August 30, 2019

Re: Pond 001, Cell 3 Professional Engineering Annual Inspection of CCR Impoundment

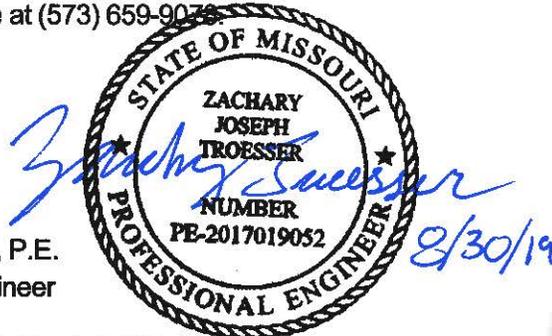
The emergency spillway elevation has been slightly increased since the last annual inspection. We recommend removing the recently placed aggregate base such that the emergency spillway maximum elevation is a minimum of two feet lower than the dam's crest elevation.
